## **Spokane Park Board Agenda**

## Design-Build Change Order Form

Change Order Number: <b>3</b>	Change Order Effective Date: <b>5/11/18</b> (date when executed by both parties)
Project: <b>PAVILION DESIGN BUILD PROJECT</b>	Design-Builder's Project No:
	Date of Agreement: <b>APRIL 13, 2017</b>
Owner: <b>CITY OF SPOKANE - PARKS &amp; RECREATION DIVISION</b>	Design-Builder: <b>GARCO CONSTRUCTION, INC.</b>

**PAVILION DESIGN BUILD PROJECT**  
**Change Order #3**  
**Backup Documentation**

1 TYPE 1 WAYFINDING DEVICE PLAN  
1" = 1'-0"

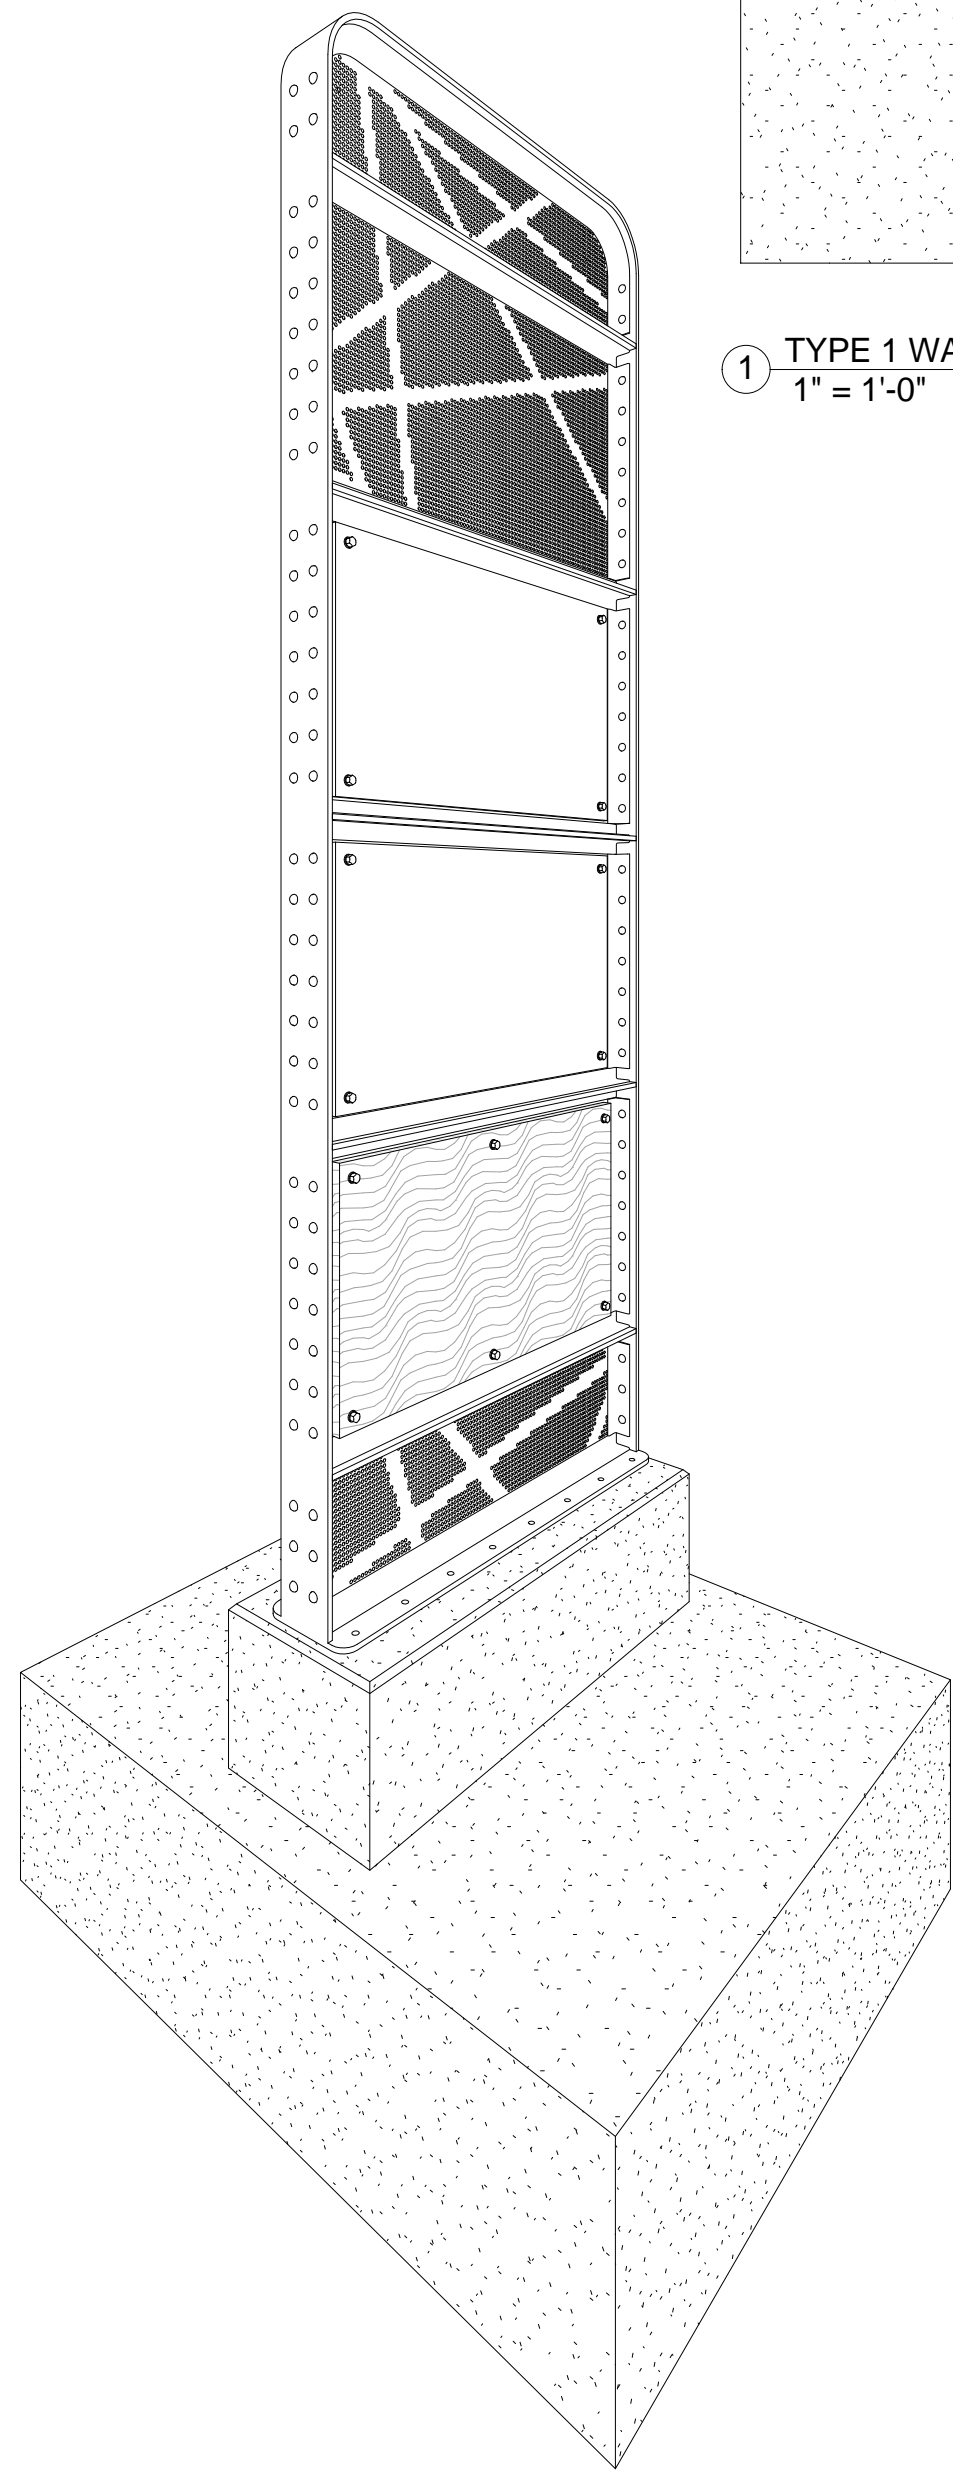
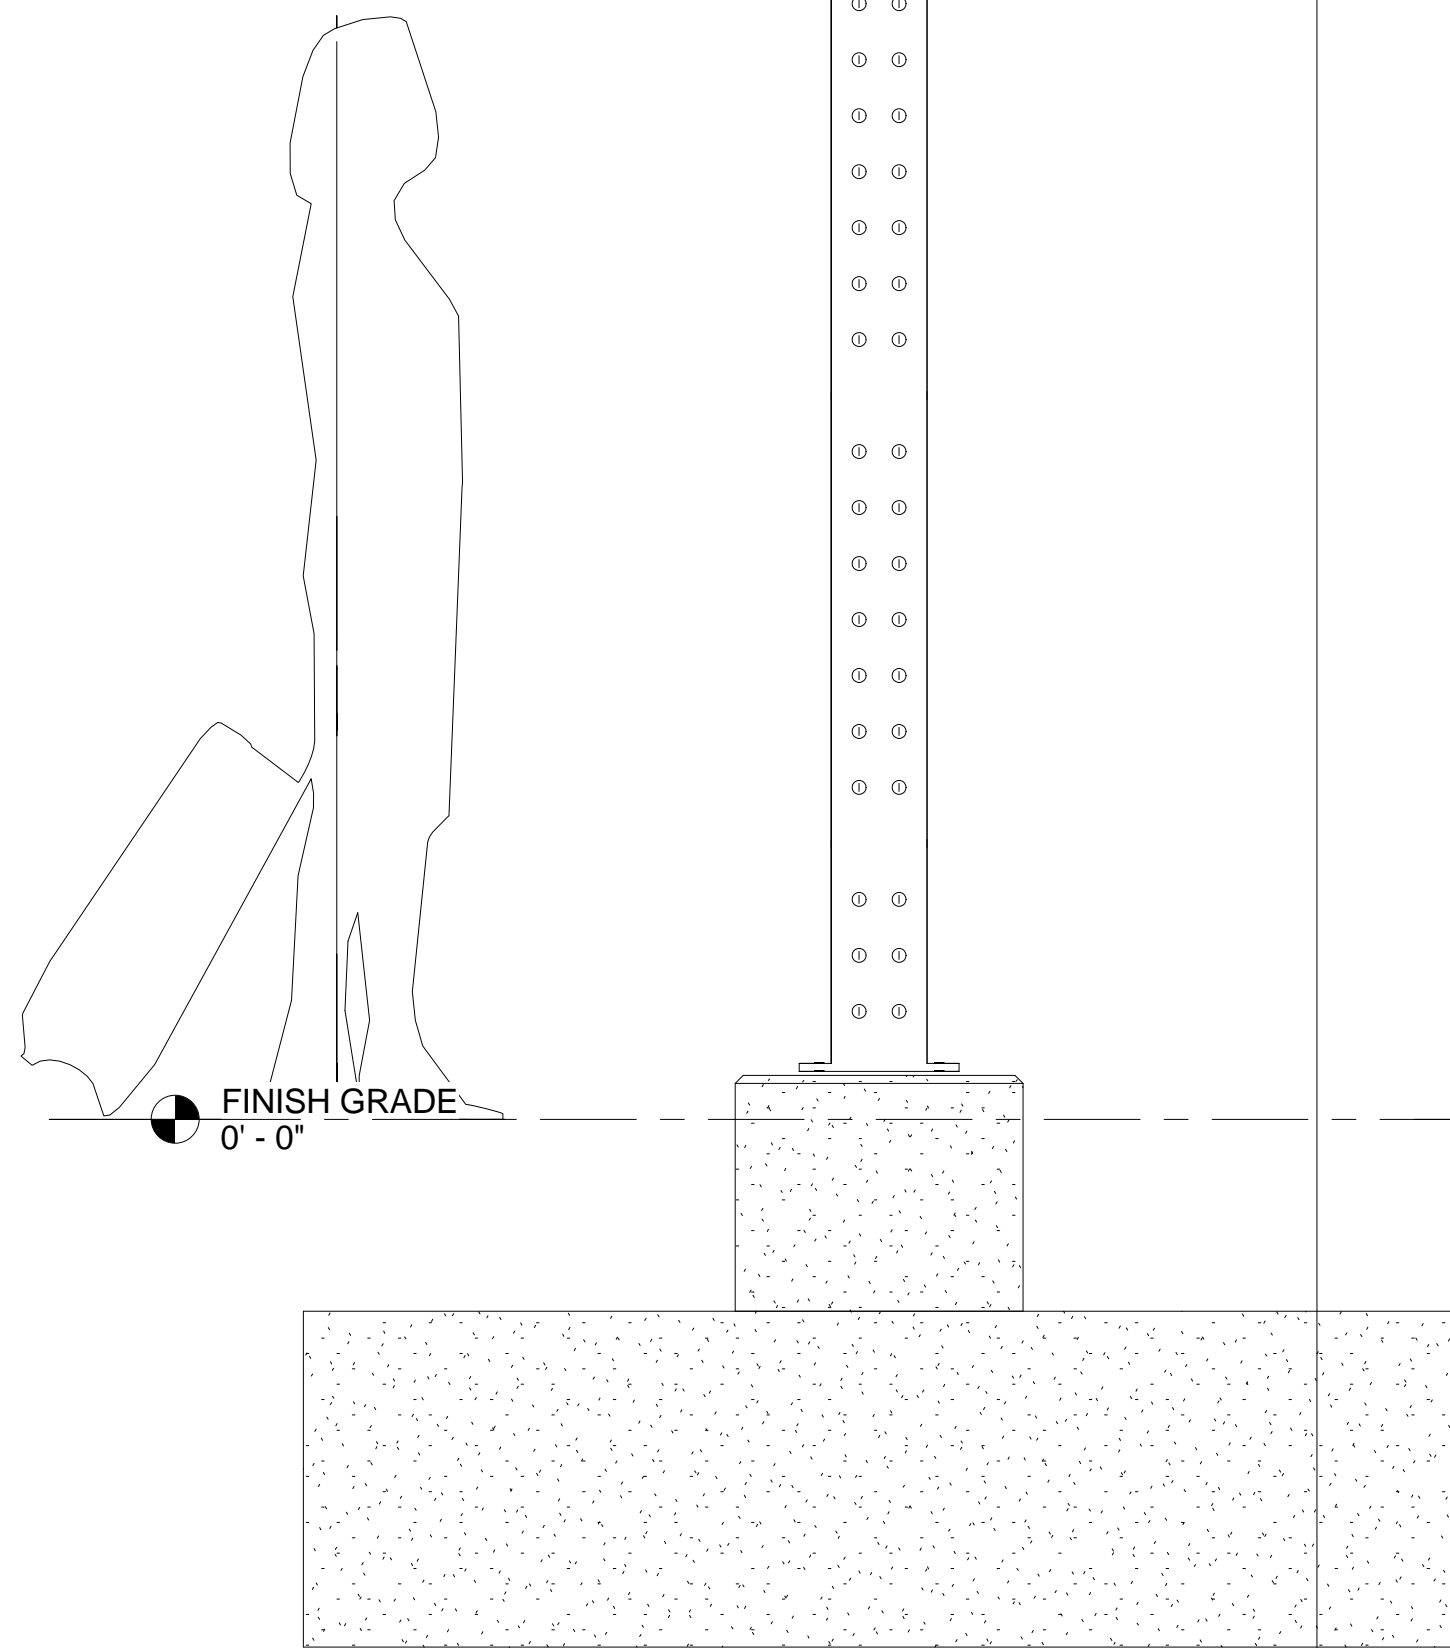
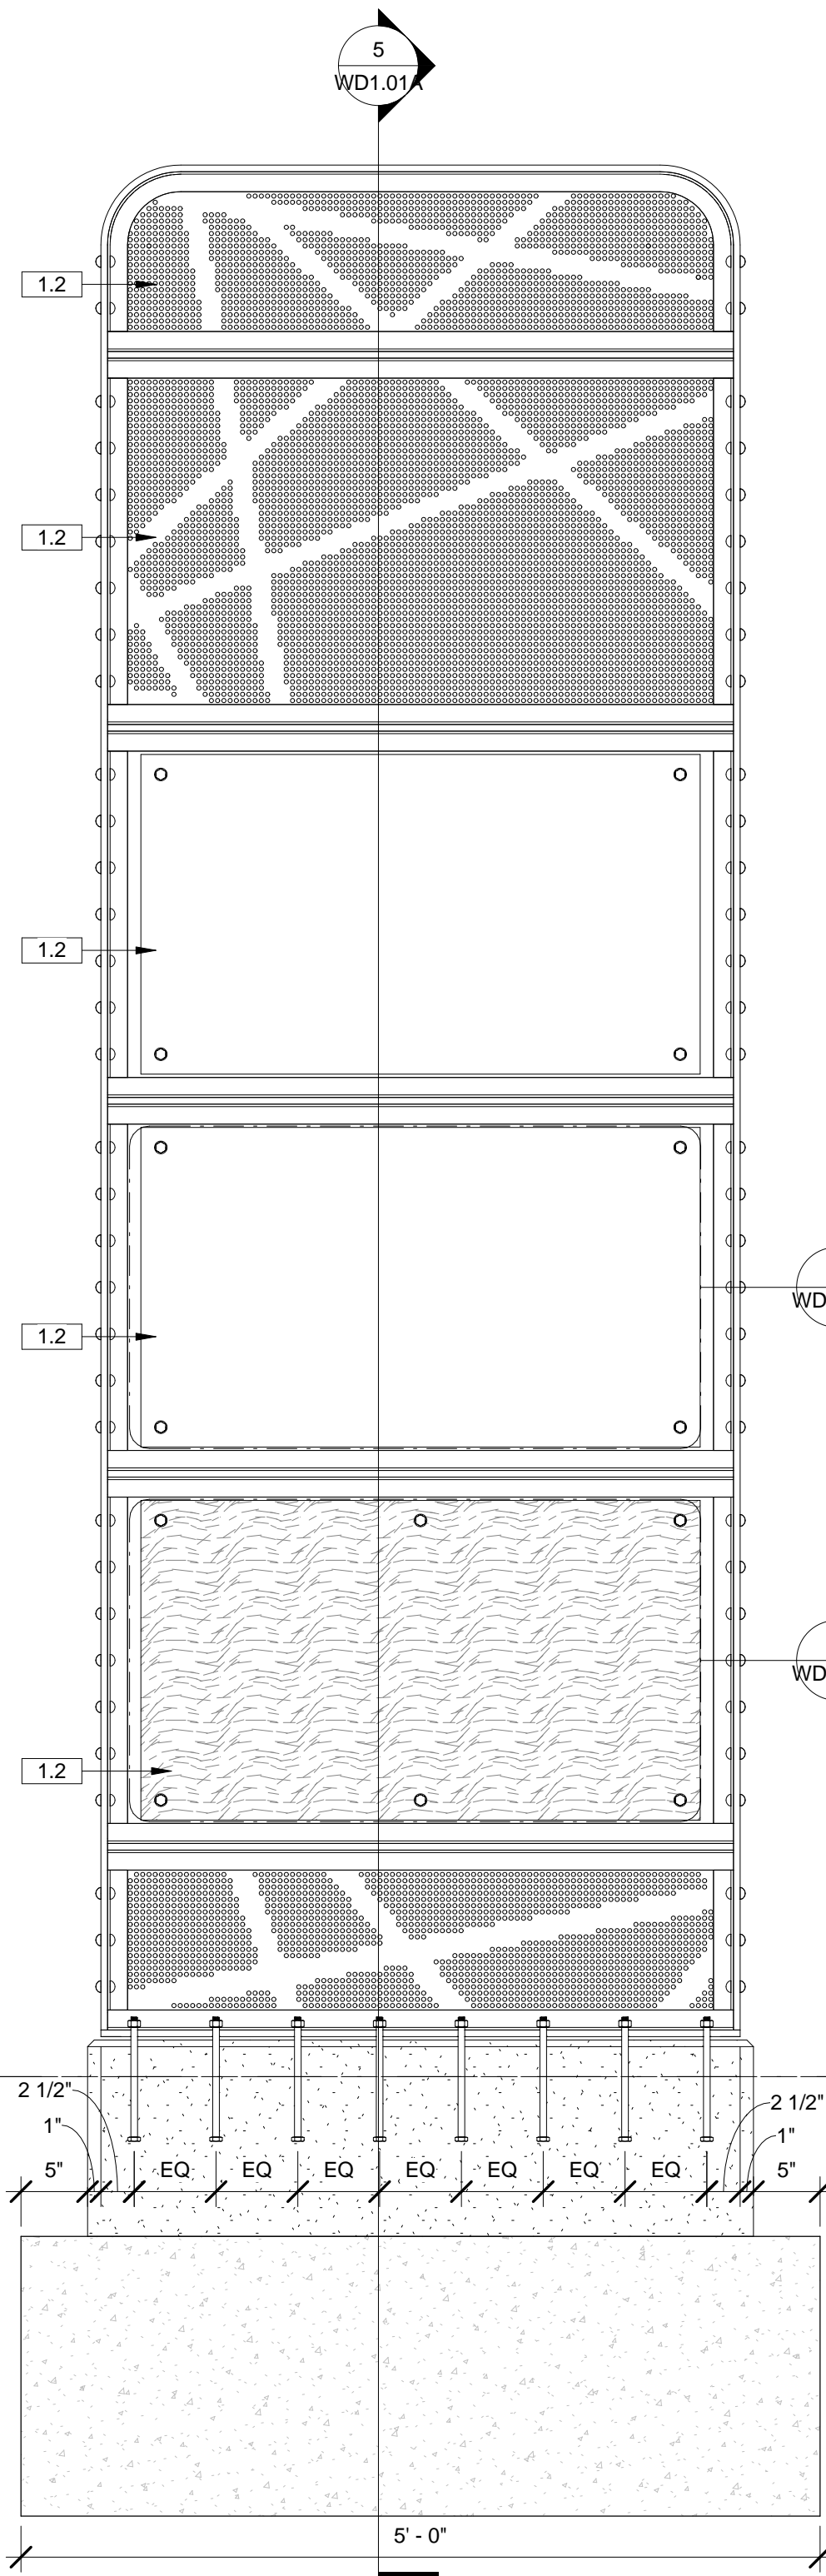
**Description:** Provide pricing to place the footings for the 13 signs as defined by the attached Wayfinding Master Plan, before the promenades finishes are installed. The requirements for the sign types and required footings are shown on the attached detail drawings from the South Bank Wayfinding package. The signage and graphics part of the sign will be issued as a change at a later date.
